**Olive Downs Coking Coal Project**

Additional Information to the  
Environmental Impact Statement

**Section 15**

**Cumulative Impact Assessment  
– Hydrology and Flooding**

Figure 15-1

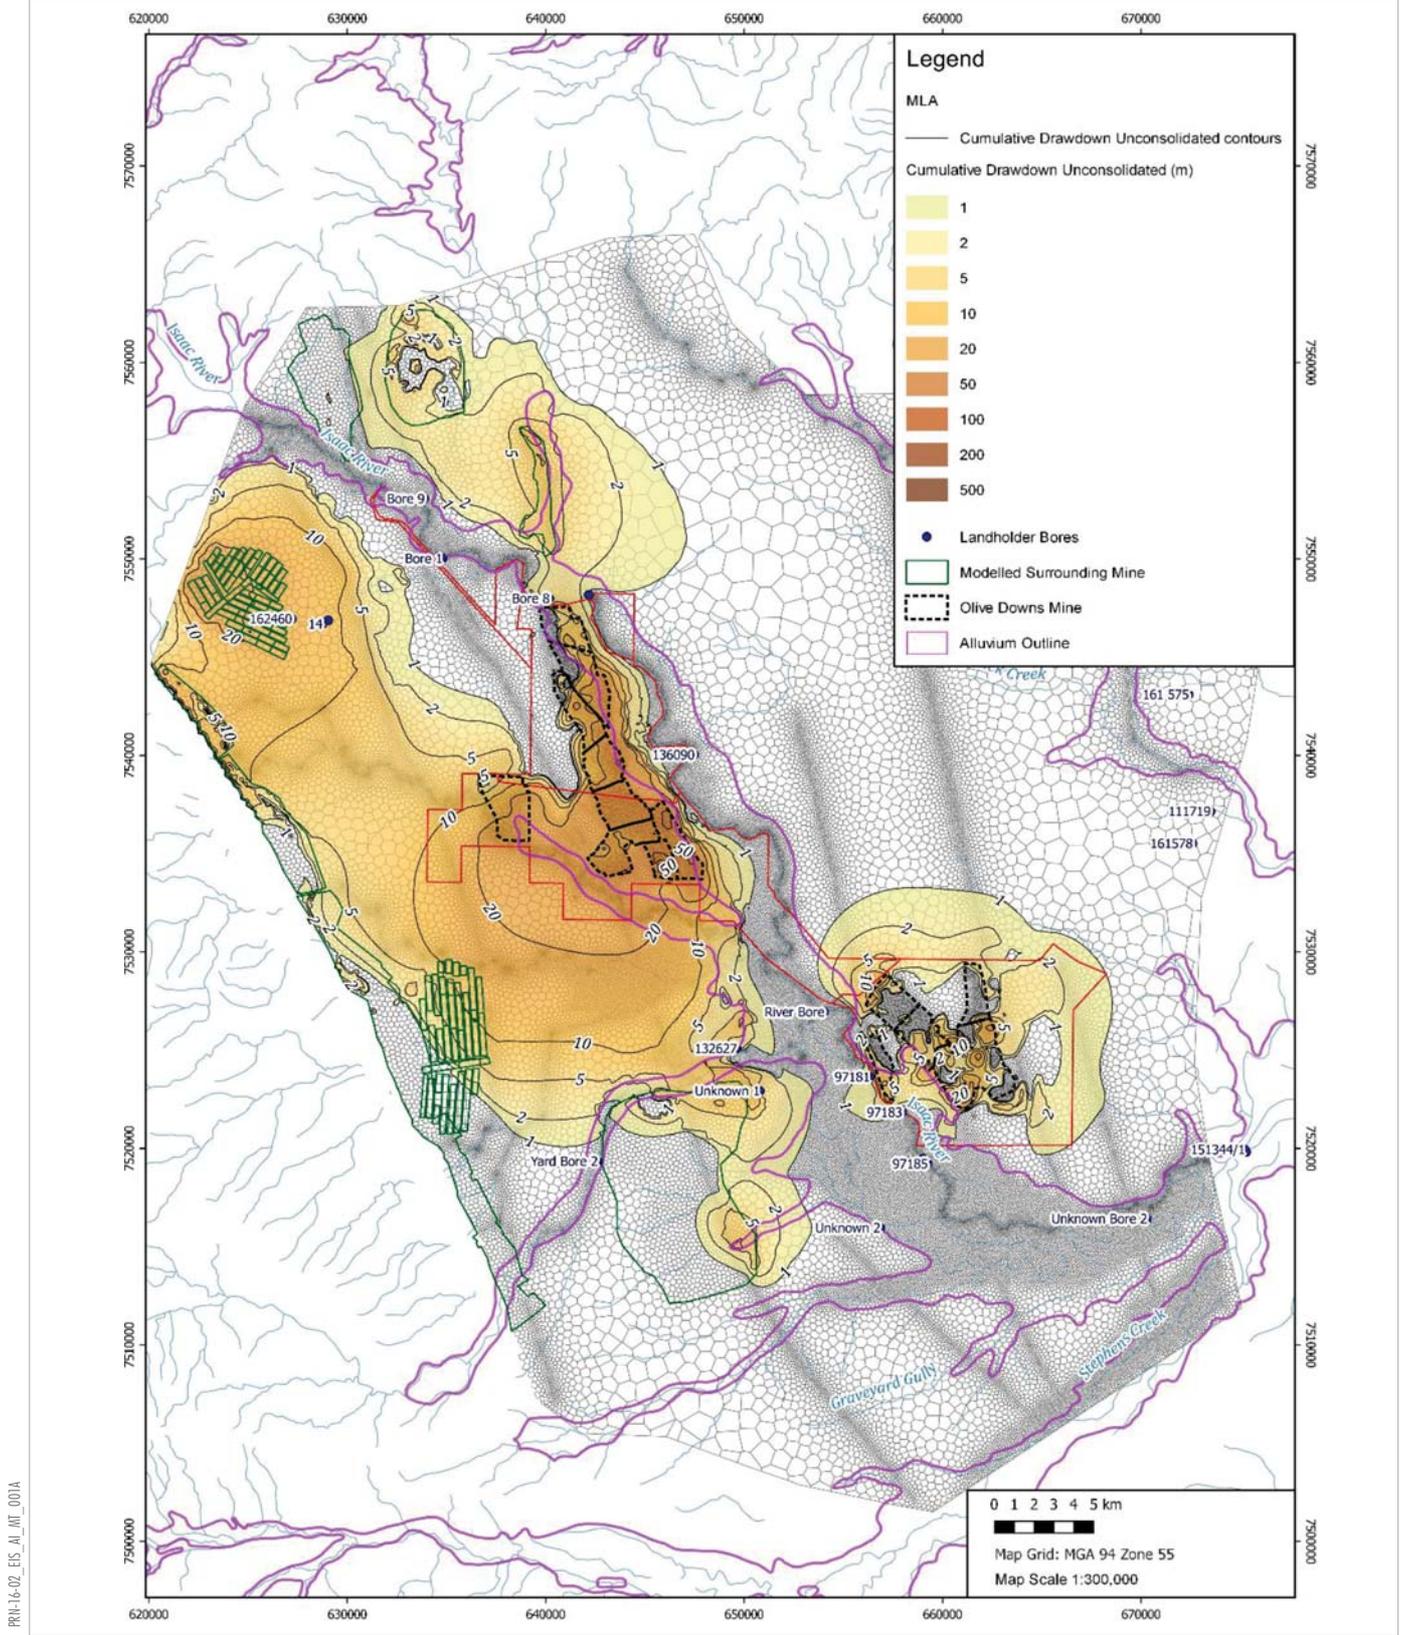
- 1. Further assessment of the cumulative impacts of the project to groundwater and surface water hydrology is required in response to the breadth of issues raised by DES and the IESC. The scope of further cumulative impact assessment is well defined in DES and IESC submissions.**

Figure 6-6 of the Groundwater Assessment (reproduced as Figure 15-1 below) demonstrates the maximum cumulative drawdown within alluvium and regolith (maximum drawdown within saturated extent of layer 1 and layer 2 combined) for the Project. The figure shows the zone of depressurisation from surrounding open cut and underground mines has reached the zone of impact from mining at the Olive Downs South domain. The magnitude of drawdowns is greatest in or closely around the mining area, and gradually reduces with distance from the mine. The zone of depressurisation from the Willunga domain is not affected by mining at surrounding mines.

Modelling of the potential drawdown impacts in the alluvial system along the Isaac River indicates that cumulative drawdown impacts are only predicted at the northern extent of the Olive Downs South domain (Figure 15-1). The cumulative impacts are associated with the Project and the Moorvale South Mine, and are predicted to result in a groundwater drawdown in the Isaac River alluvium of approximately 2 m (or less).

Olive Downs EIS 2% AEP Afflux Map (Developed vs. Existing)

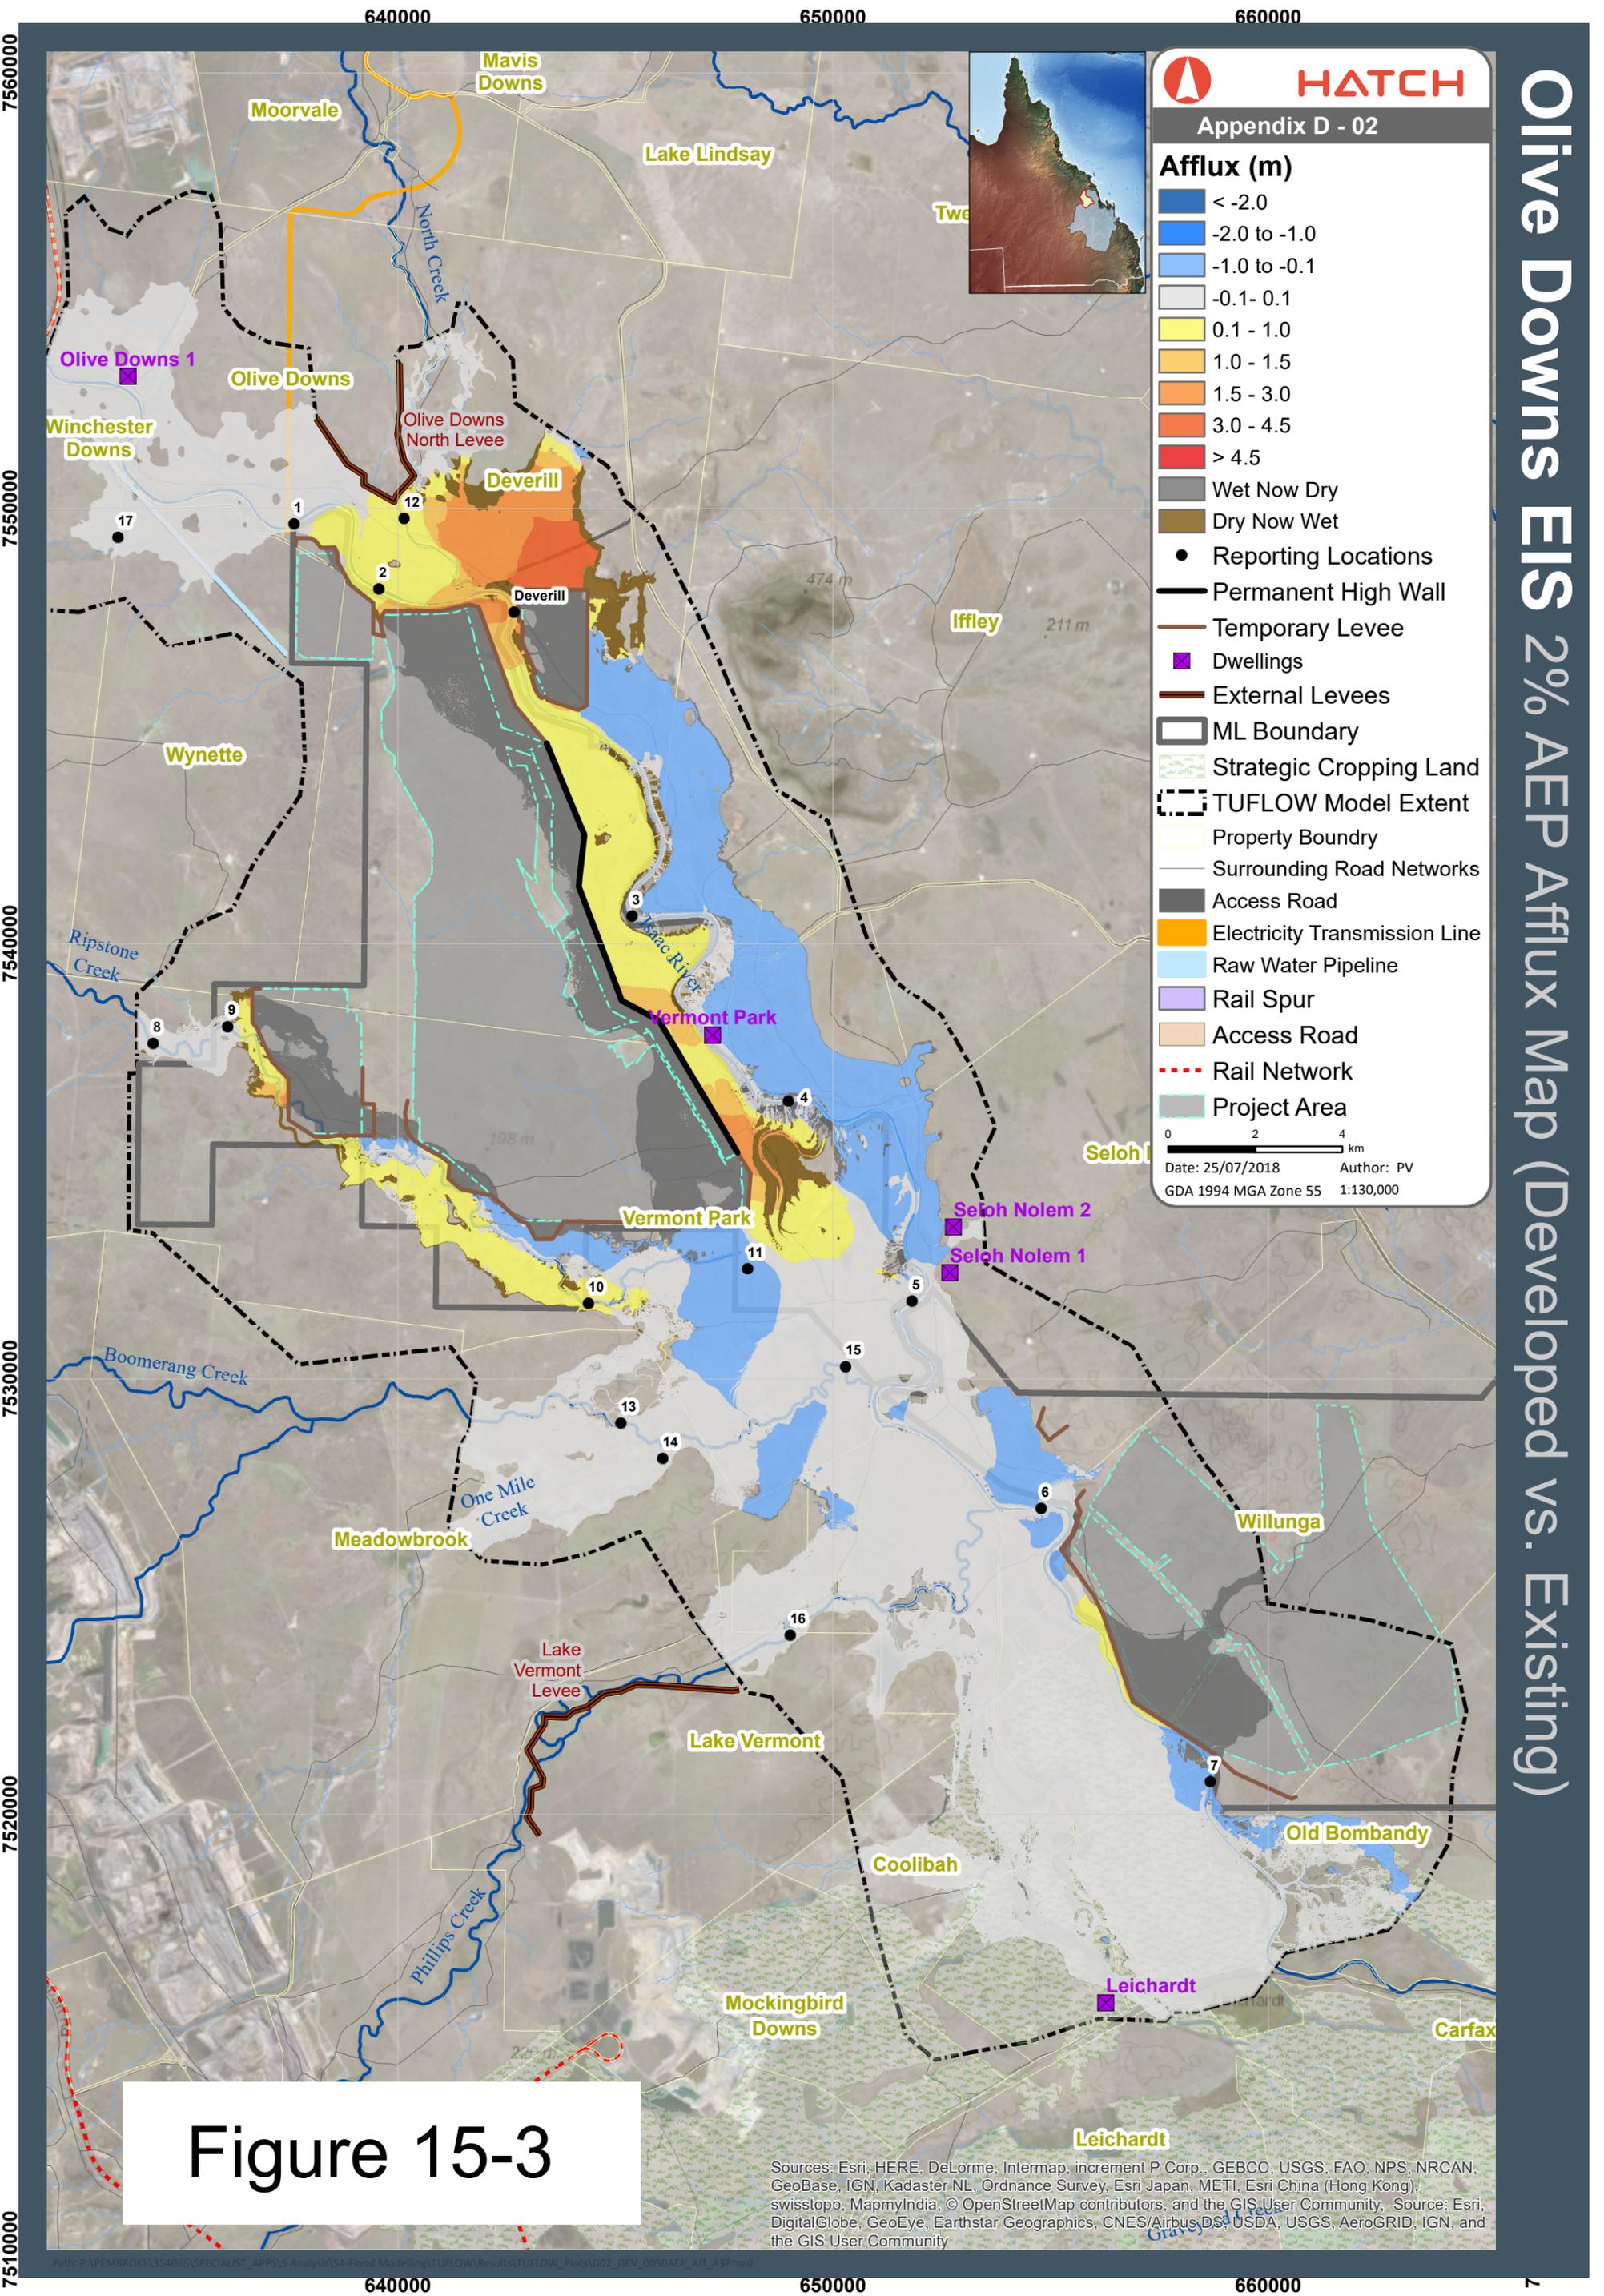
**c) *An assessment of potential cumulative impacts of mining activities on water resources downstream***

As shown on Figure 15-3, changes to flood characteristics are predicted to be negligible within approximately 2 km downstream of the Project. Accordingly, impacts to downstream water resources associated with changes to flood characteristics are predicted to be negligible.
